Chatten-Brown, Carstens & Minter LLP

July 13, 2021

RE: EIR for the Mount Saint Mary's Chalon Campus Wellness Pavilion Project -
Draft EIR, No. ENV-2016-2319-EIR (SCH No. 2016081015) dated April 2018,
and the Final EIR, dated June 2021; CPC-1952-4072-CU-PA1; and ZA-2017-
928-ZAD

FIGURE 4 – Mountain Lion Predations Sites – Note Proximity to Proposed Project

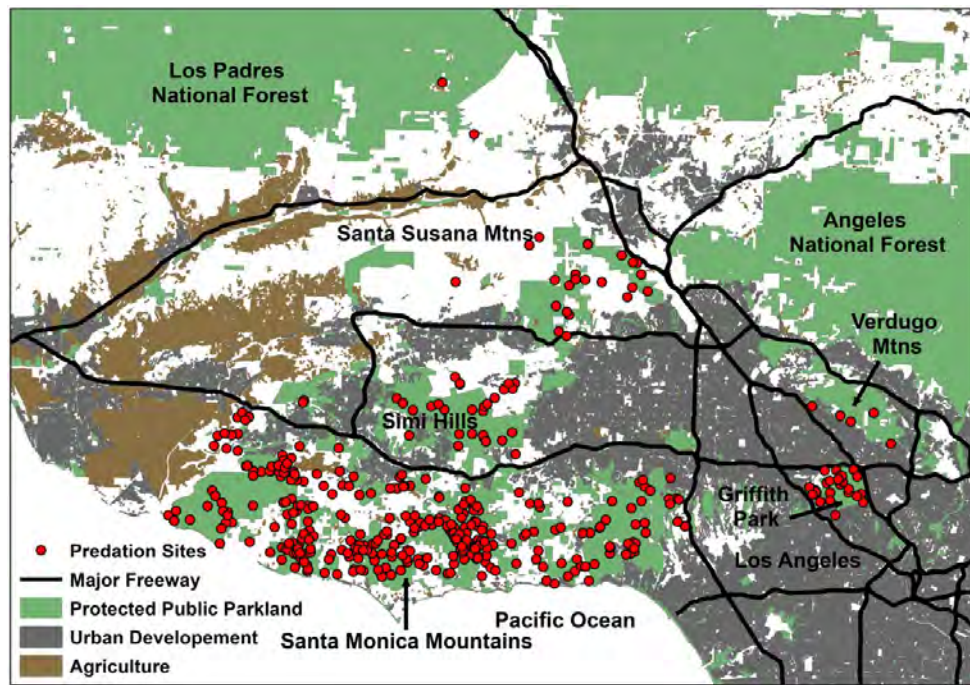
In addition, as shown in **Figure 4**, the Project Site is located in close proximity to recorded Mountain Lion predation sites.

According to page B-13 of the FEIR: “[u]nder either the Project or Alternative 5, the fuel reduction area adjacent to the Project Site would be extended to maintain a 200-foot distance from the broader foundation footprint of the Wellness Pavilion.” **Figure IV.C-1**, reproduced from page IV.C-10 of the DEIR, shows the proposed Project’s location in relation to native habitat (0.4 acres of Greenbark Ceanothus Chaparral and 0.5 acres of Laurel Sumac Scrub). According to Table IV.C-1 of the DEIR, this native habitat is located within the fuel modification zone for the proposed Project. According to page III-46 of the FEIR: “[a]s with the Project, Alternative 5 would result in the expansion of the Project Site’s 200-foot fuel modification zone into 0.9 acres of native plant communities (i.e., 0.5 acre of laurel sumac scrub and 0.4 acre of greenbark ceanothus chaparral).” The proposed Project and Alternative 5 would thus result in the loss of 0.9 acres of native habitat in an area used by mountain lions as a wildlife corridor and where mountain lions feed.

Figure III-1
Alternative 5 Site Plan

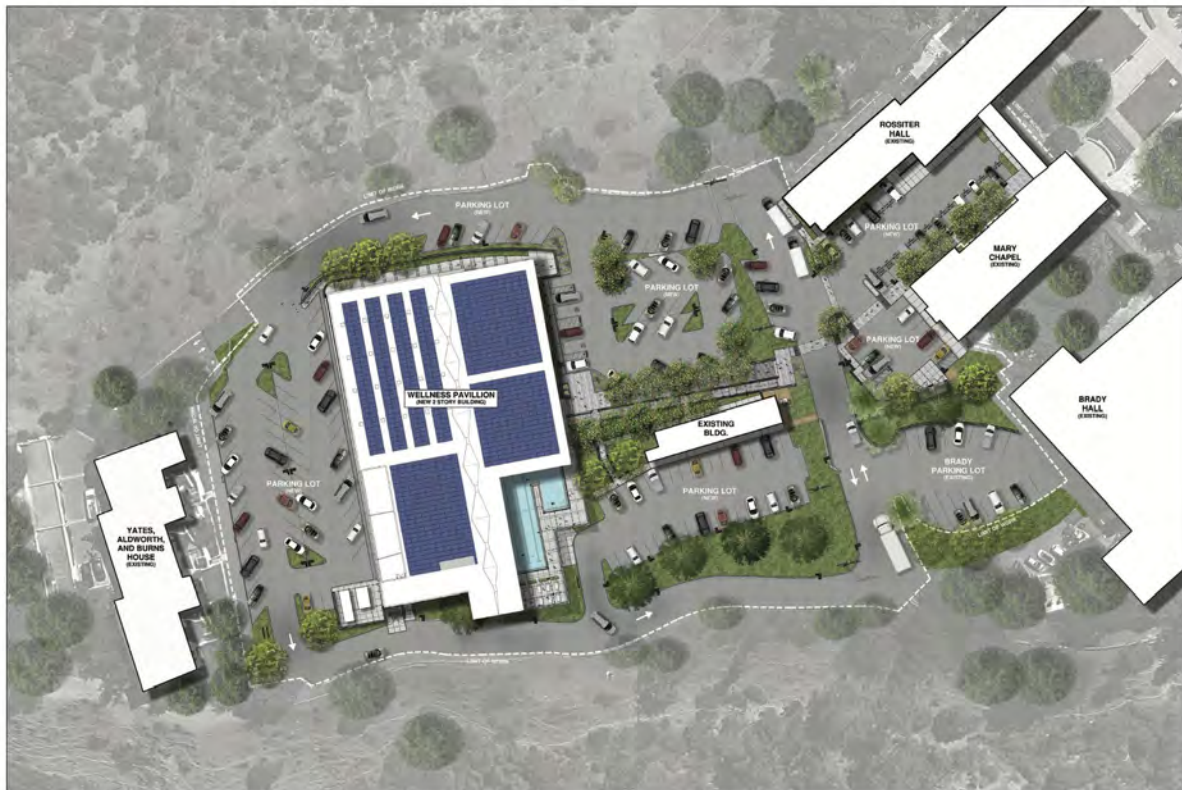
Project plans for Alternative 5 have not been provided in the FEIR. **Figure III-1** from the FEIR does not appear to show compliance with these access requirements. Furthermore, as detailed herein, MSMU has only one viable access road into and out of the Campus, and as noted by Mr. Rifkin (see **Attachment F**):
